# Access Compliance Report

## Public Rights-of-Way

Intersection ID: 44204	Main Street: MOCKERNUT_DR	Cross Street: COFFEE_TREE_CT	Location: SE
ADA ID: 317535635702	Ramp Type: PerpDiag	Initial Pass/Fail: Fail	Overall Compliance: No
Severity Score: 33.75			
Codes/Mitigation Info/Possible Solution		Field Measurements/Component Compliance

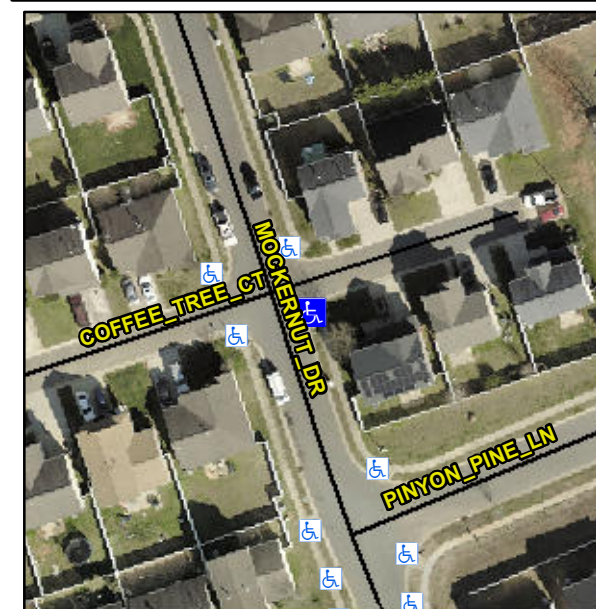
**Remove & Replace Curb Ramp With Two New Directional Ramps or Equivalent.**

**Not Found, R304.5.1, R304.2.2**

Compliance	Description	Data	Compliance	Description	Data
N/A	Ramp Length (in)	33.5	No	Ramp Slope (%)	12.6
No	Ramp Width (in)	39.5	Yes	Ramp XSlope (%)	0.7
N/A	Flare Type LT	N/A	N/A	Flare Type RT	N/A
N/A	Flare Slope LT (%)	N/A	N/A	Flare Slope RT (%)	N/A
N/A	Flare Traversable LT?	N/A	N/A	Flare Traversable RT?	N/A
N/A	Landing Length (in)	N/A	N/A	DWS Provided?	N/A
N/A	Landing Width (in)	N/A	N/A	DWS Contrast?	N/A
N/A	Landing Slope (%)	N/A	N/A	DWS Length (in)	N/A
N/A	Landing X Slope (%)	N/A	N/A	DWS Full Width?	N/A
N/A	Landing Curb? (Y/N)	N/A	N/A	DWS Offset (in)	N/A
N/A	Shared Landing?	N/A			
N/A	Gutter Ponding?	N/A	N/A	Gutter Slope (%)	N/A
N/A	Gutter Lip Ht (in)	N/A	N/A	Gutter X Slope (%)	N/A
N/A	Painted X Walk1?	No	N/A	Painted X Walk2?	No
	X Walk 1 Direction	To N		X Walk 2 Direction	To W
N/A	X Walk 1 Width (in)	N/A	N/A	X Walk 2 Width (in)	N/A
	X Walk 1 Slope (%)	2.7		X Walk 2 Slope (%)	1.8
	X Walk 1 X Slope (%)	0.6		X Walk 2 X Slope (%)	4.5
